# UNITED STATES PATENT AND TRADEMARK OFFICE

APPLICATION NO.	FILING DATE	FIRST NAMED INVENTOR	ATTORNEY DOCKET NO.	CONFIRMATION NO.
10/814,412	03/31/2004	Goichi Katayama	FS.20133US0A	5695

**Office Action Summary**

## **DETAILED ACTION**

**FIG. 3b**

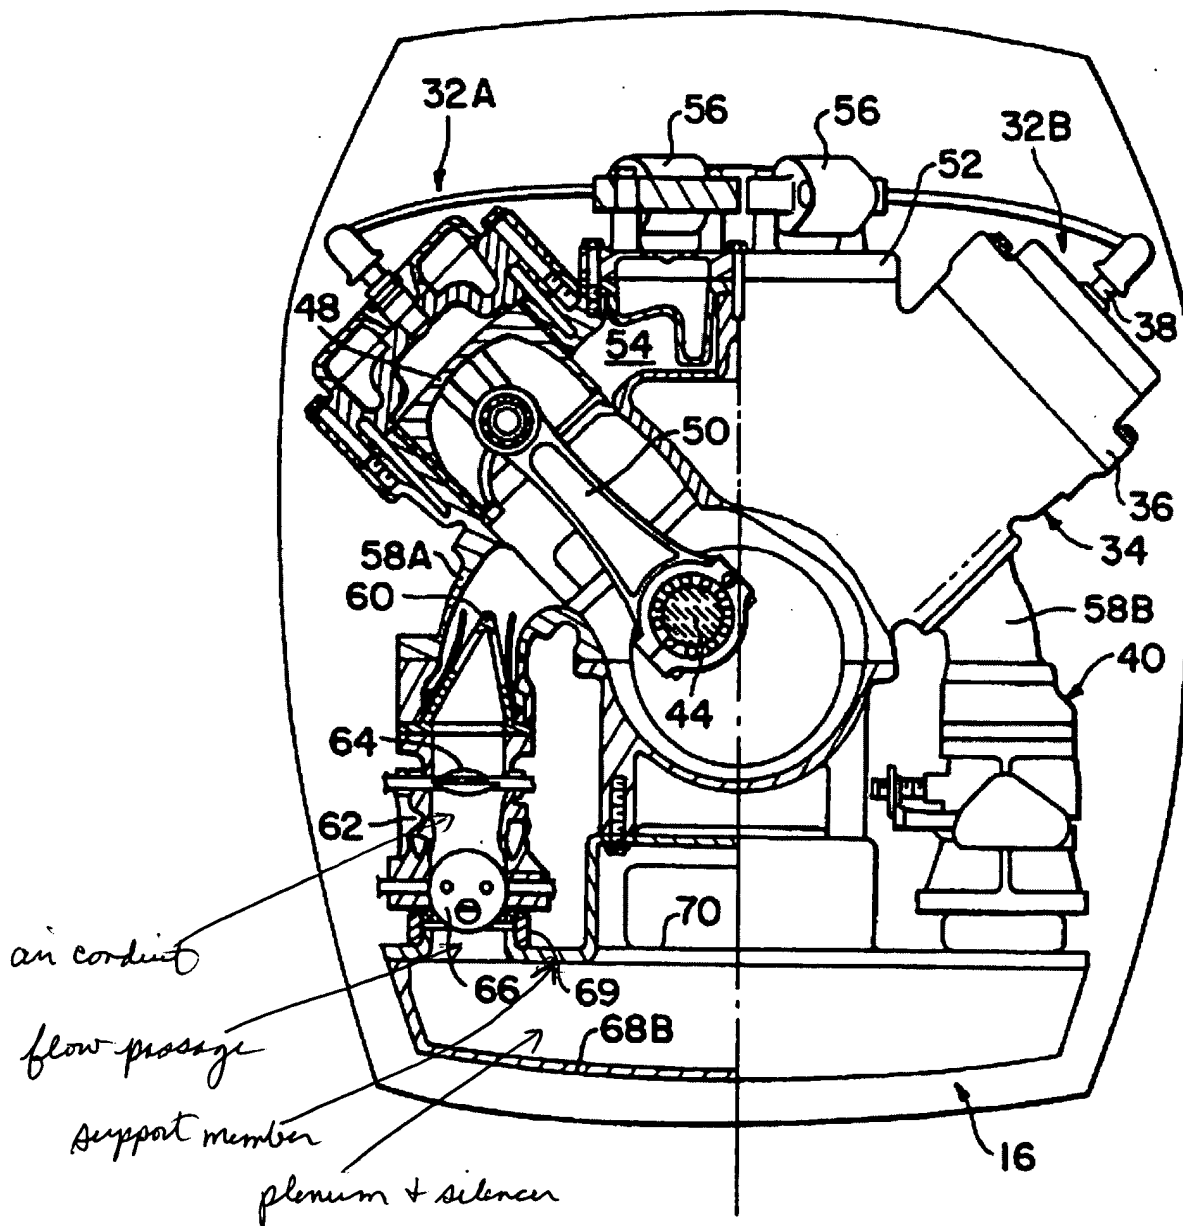
Claims 1-2, 4-7, 9-15, 19-20, and 27-31 are rejected under 35 U.S.C. 102(b) as being anticipated by Takahashi et al (5,349,928). Note an engine comprising an engine body including a plurality of combustion chambers and an air induction system for supplying air to the combustion chamber, the air induction system comprising a support member (or with respect to claims 16, 19, and 30, an induction air support member) attached to the crankcase and defining at least one flow passage, a flow control device 66, in throttle body 62, and supported by the support member and communicating with the flow passage so as to regulate an amount of air flow through the flow passage, and at least two runners (or with respect to claims 16, 19, and 30, induction air passages) 58A, 58B, the runners positioned on opposite sides of and attached to the engine body from each other and being in fluid communication with at least one corresponding combustion chamber and with the flow passage of the support member, one end of each runner being supported by the support member and the other end of each runner being supported by the engine body, the flow passage being positioned to deliver air flow from the flow control device to the ends of the runners supported by the support

member, plenum chamber housing 68A comprising a plenum chamber which also acts as a silencer and includes an air intake port 70. See below.
